Federal Aviation Agency

CERTIFICATION:
PILOT AND FLIGHT
INSTRUCTORS

SUBJECT: CORRECTION TO KOCH CHART IN AC 61-11 AND AC 61-28

Koch chart for computing takeoff distance and rate of climb.

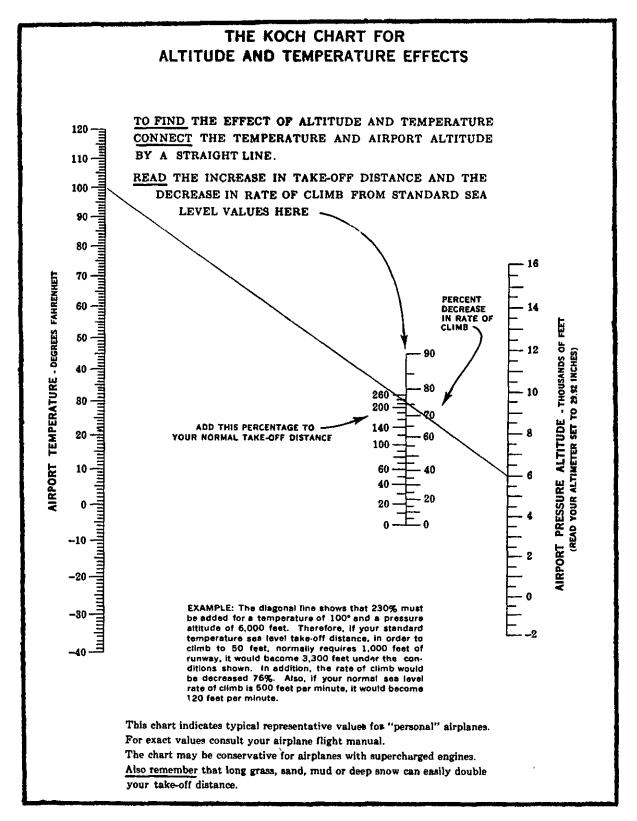
- a. The Koch chart, dated 5-5-64, shown in AC 61-11, pages 37 and 62, and in AC 61-28, page 68, has been rescinded. A corrected Koch chart, shown on the reverse side of this advisory circular, should be used in place of the one dated 5-5-64, which was used in AC 61-11 and AC 61-28.

- c. AC 61-11, Airplane Flight Instructor Examination Guide, will contain an errata page with the correct chart which will be inserted in the present stock. The next reprint of AC 61-28 will contain the corrected Koch chart on page 68.
